RE: 722 Crossway Rd. Burlingame, CA
Resubmittal with request for alterations to design.

3/27/19

To the Design Counsel Board,

WALL EYE ATTACHMENT DETAIL

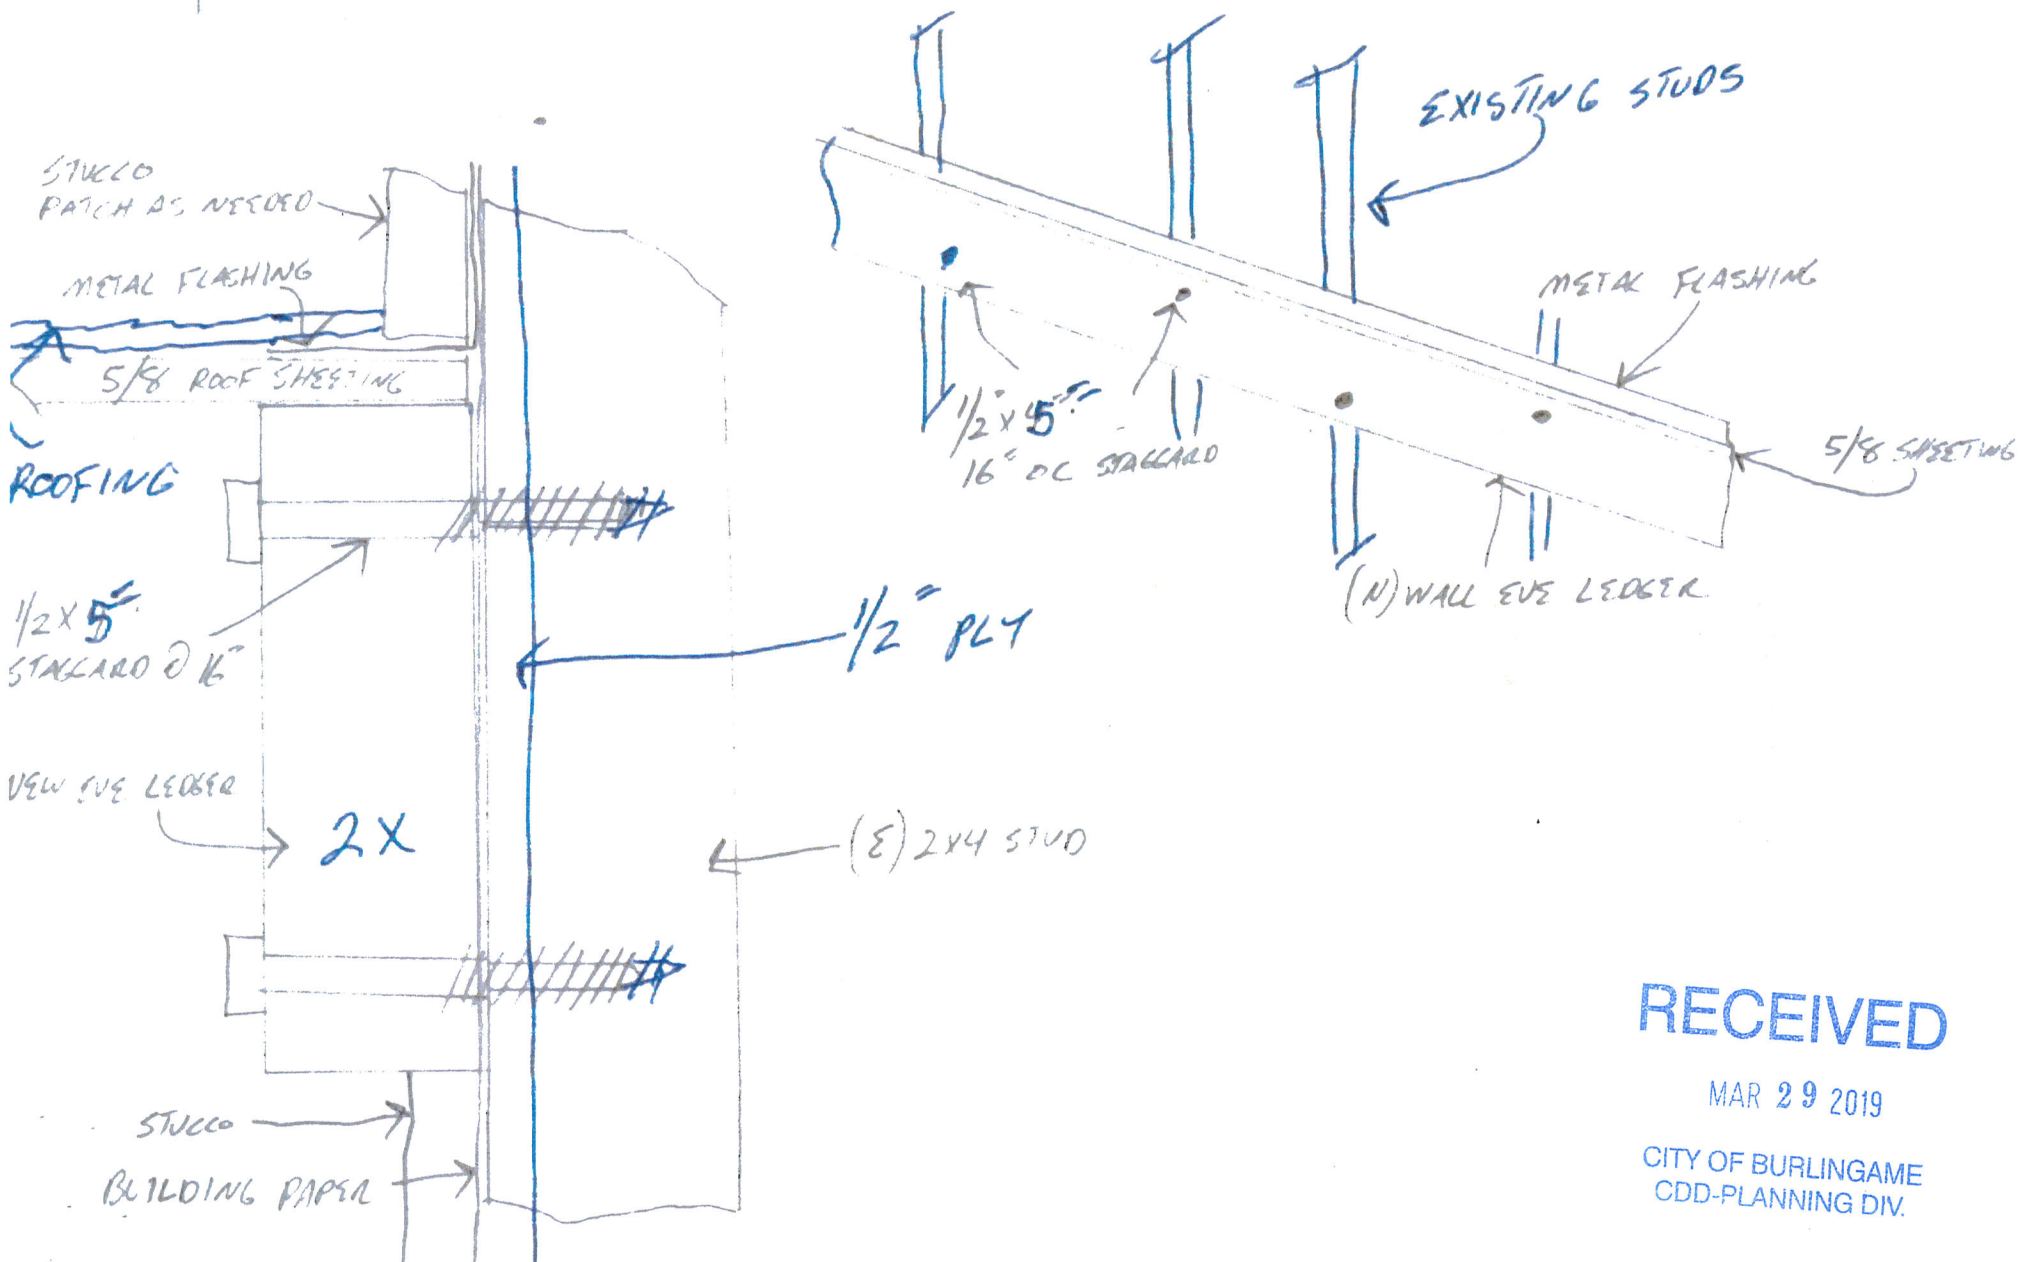
Note: The new roof eve (at all plans, A, B, C) would be secured to the side walls of the house by SDS screws and properly flashed. Stucco will be removed at those contact points.

ORIGINAL APPROVED PLAN

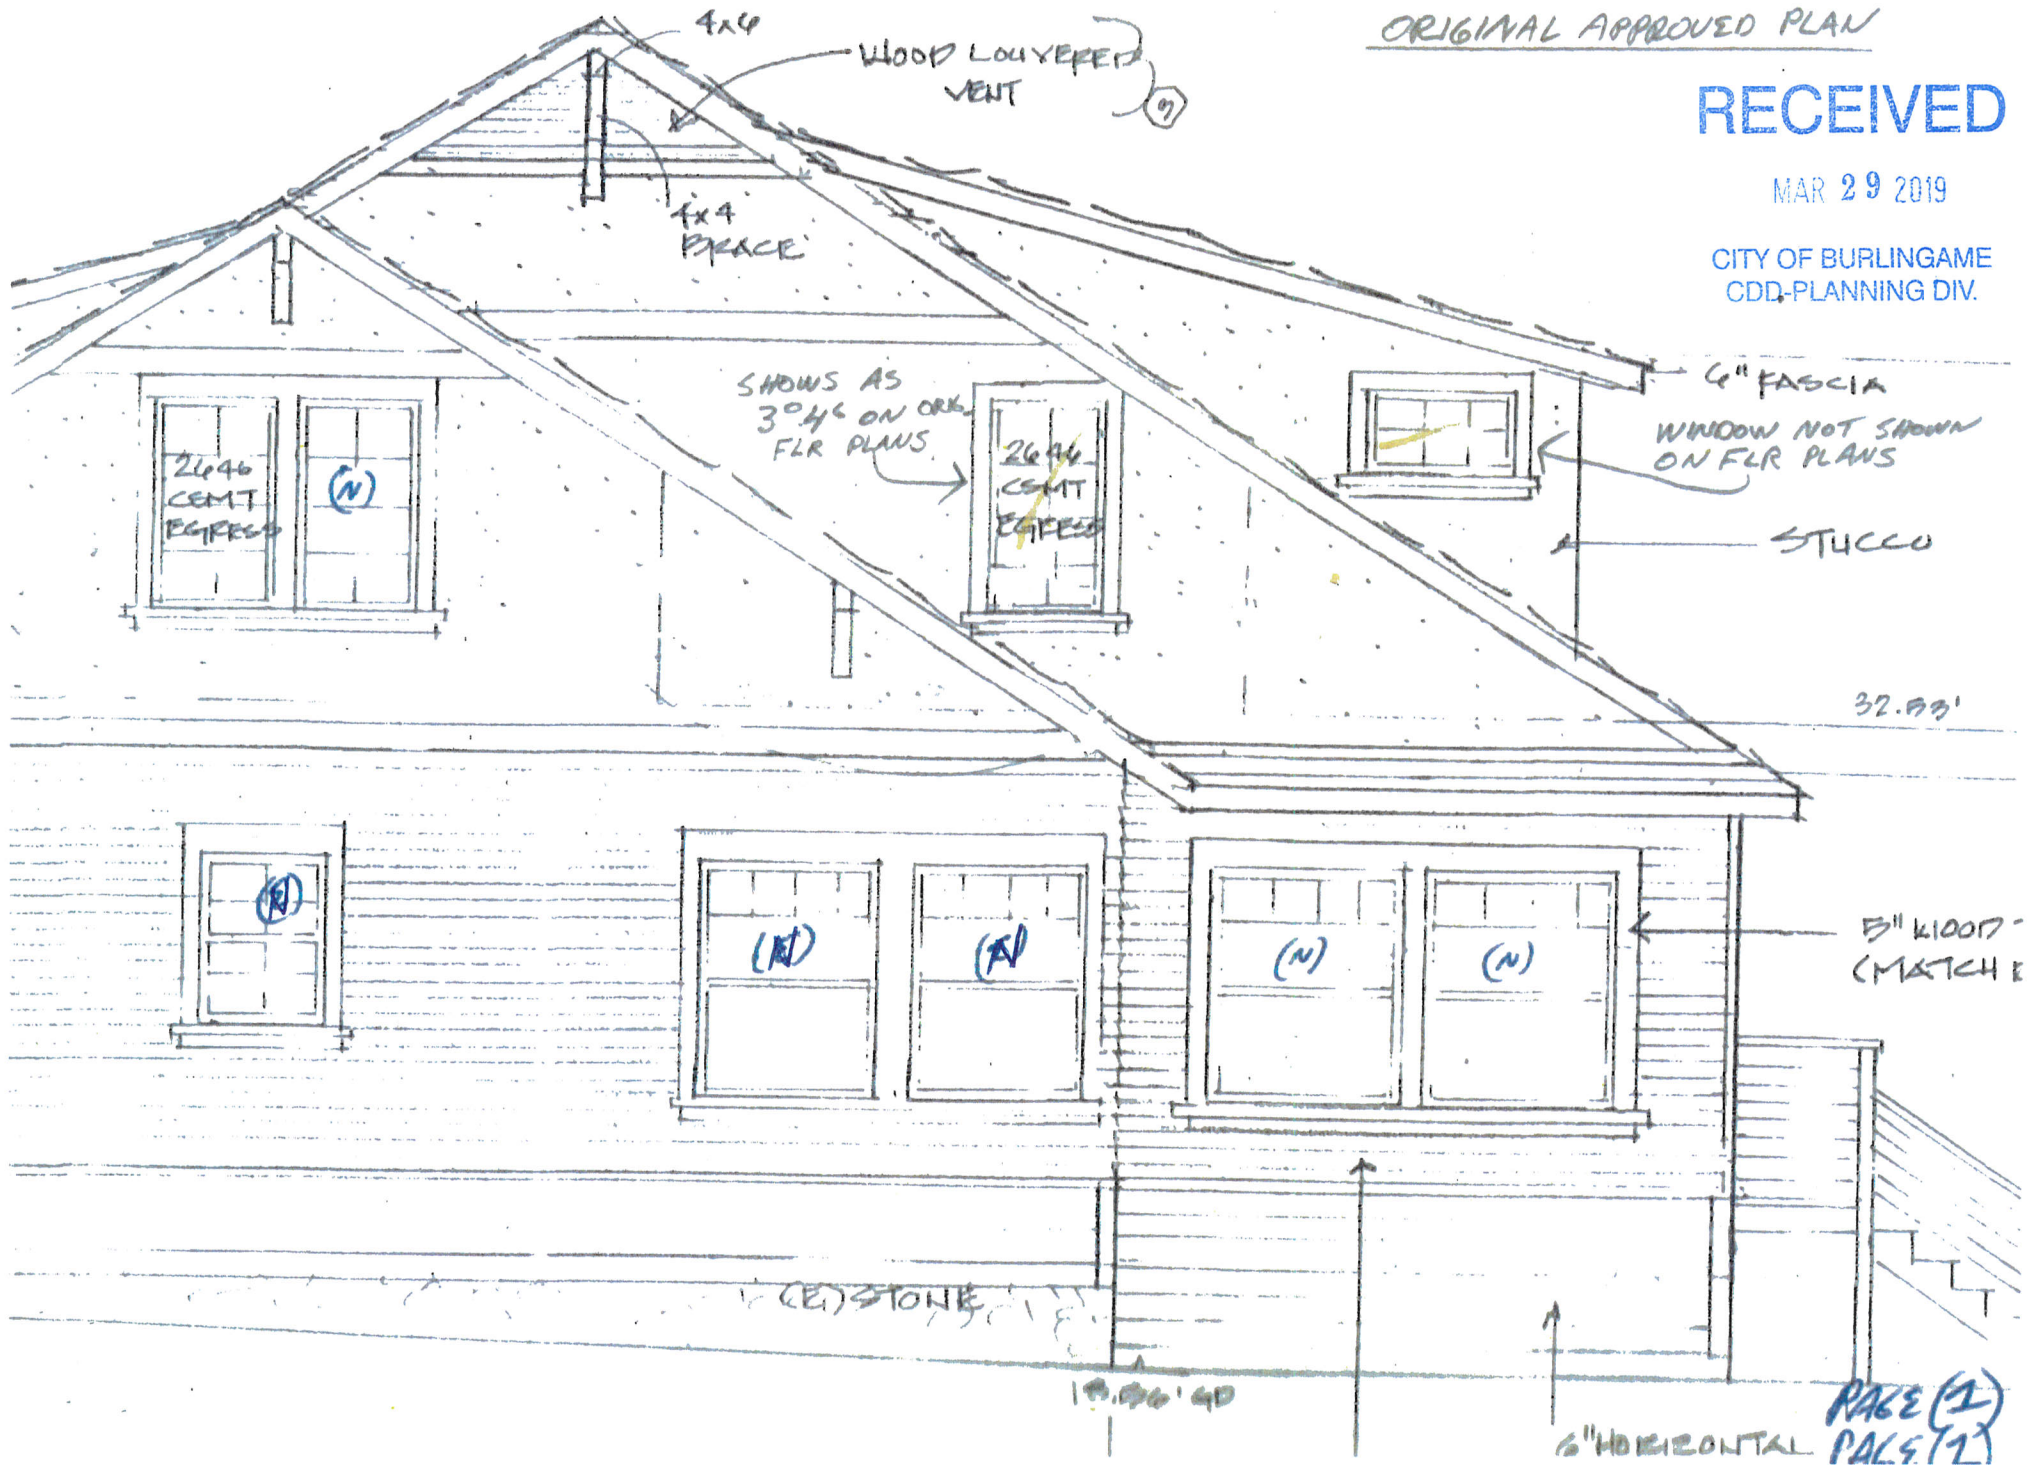
Page (1): This page is a copy of the originally approved side elevations in question.

Note: There are three vertical lines noted on the plans that the designer later said were not supposed to be there. They are on the originally approved plans however not visible on the existing house. Two of the lines actually line up with the new upper exterior wall corners. This made us believe originally there was some relevance to these lines.

The rear bedroom #5 window shows as a 30"X 54" sized casement window. The floor plans show a 36"X 54" which was installed. We always work off floor plan notes as does the engineer.

Master bath room shower window is shown on the plan elevations. It is not shown on floor plans or engineering. Following the floor plan as well as the homeowner not wanting a window in their shower the window was not installed.

RIGHT SIDE (AS IS)
SEE PICTURES

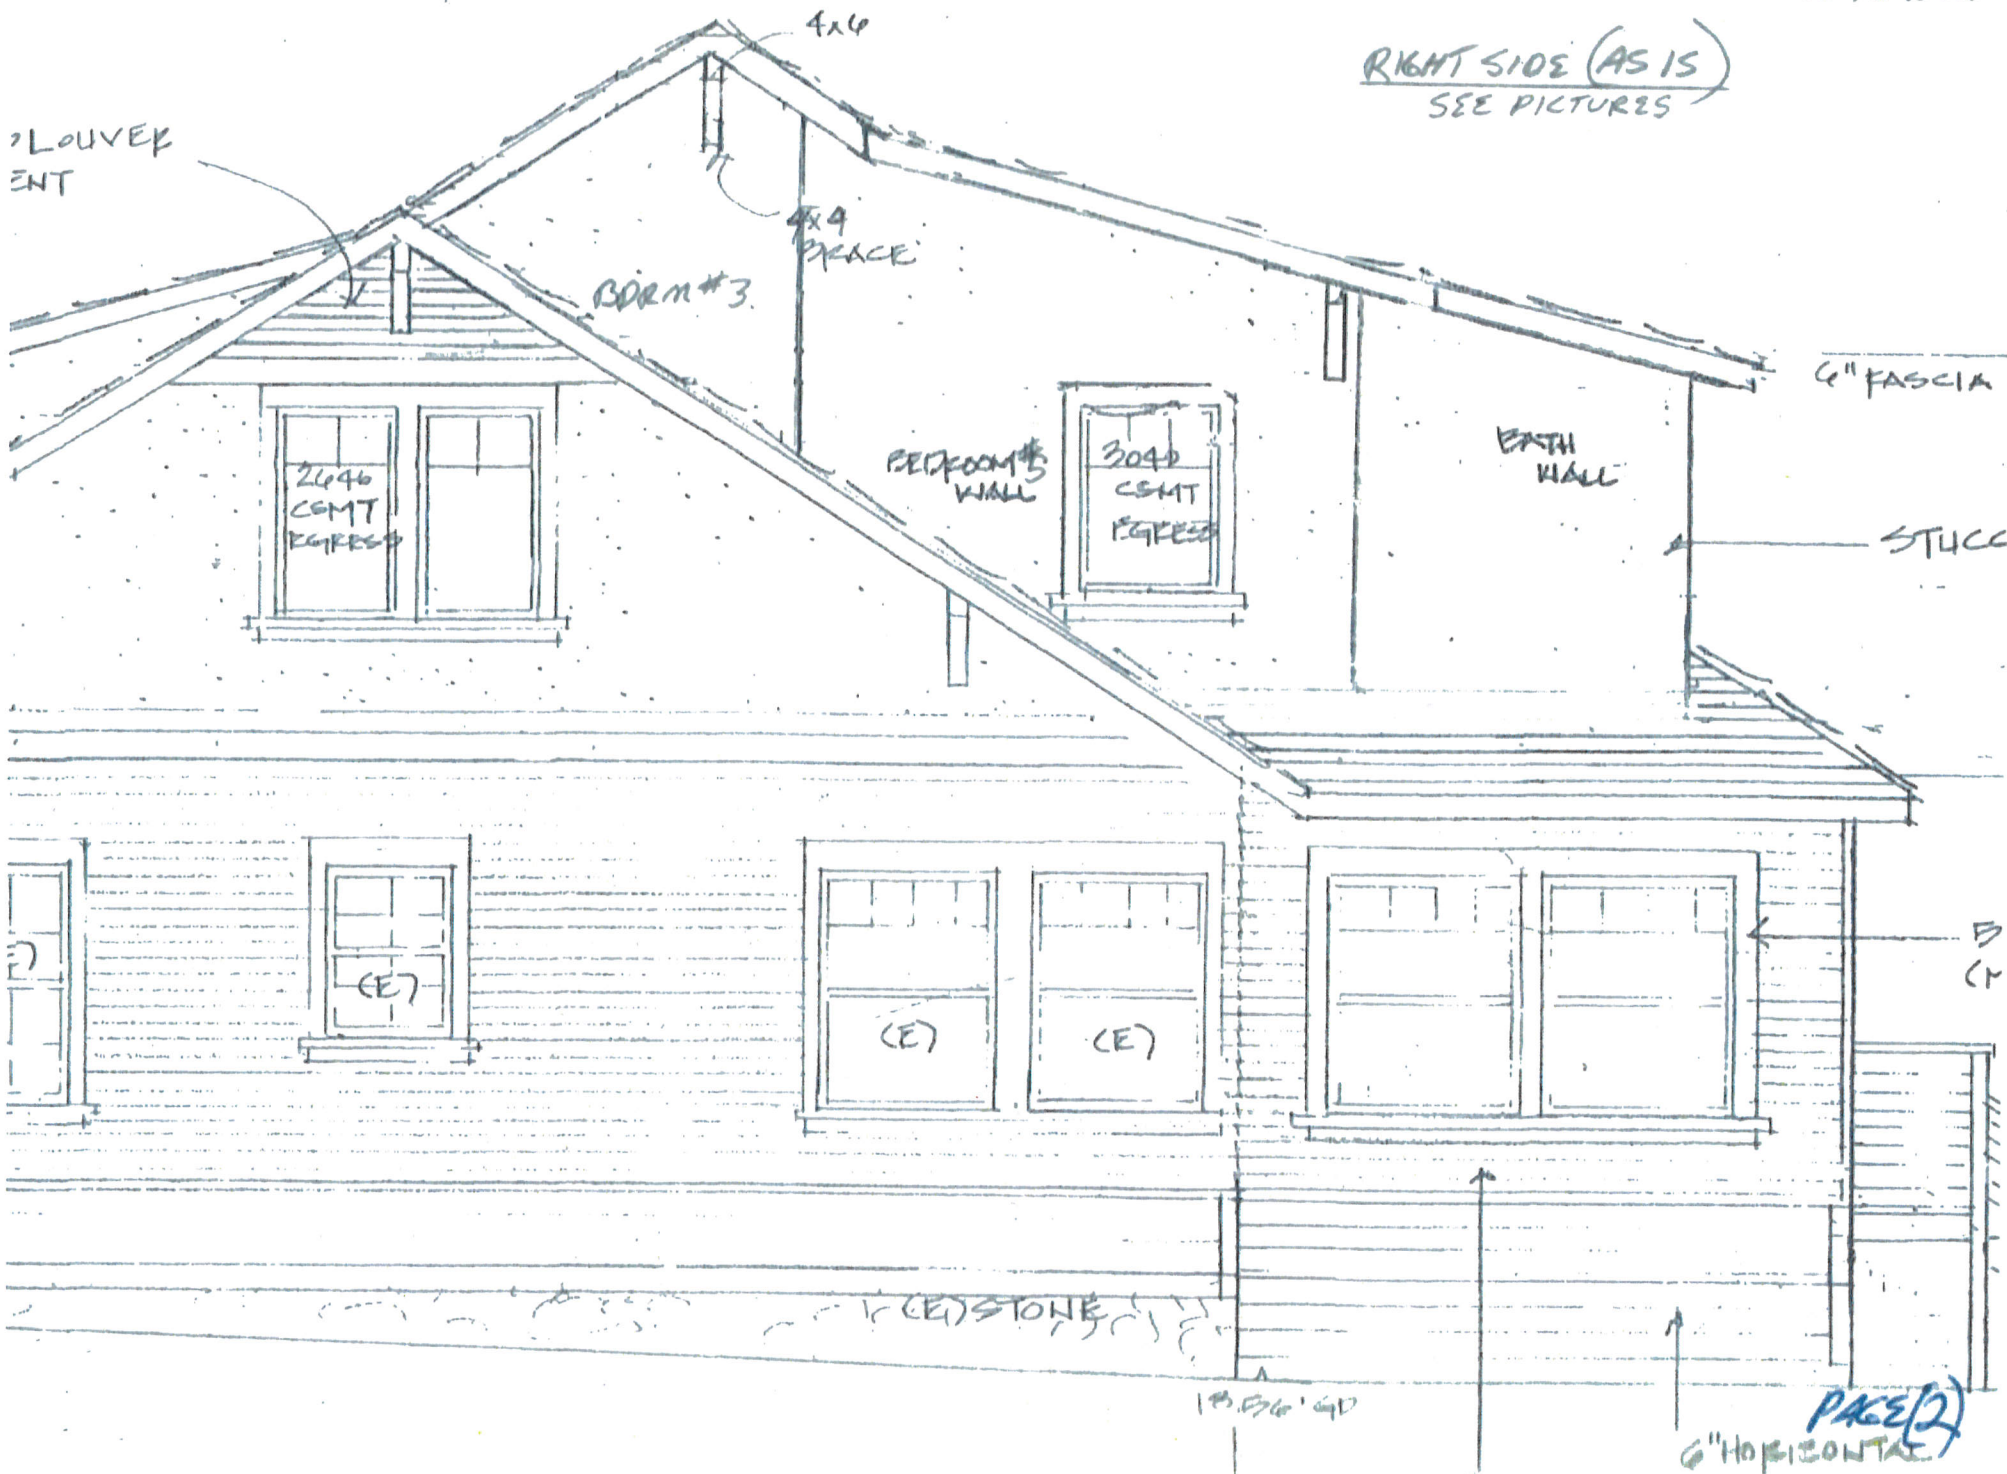
Page (2): This shows how the right side of the house was finished, without the Eyebrow roof eve. The gable vents were dropped down to the lower gable due to the exterior wall corner at the upper gable, that prevented the gable from being built as shown.
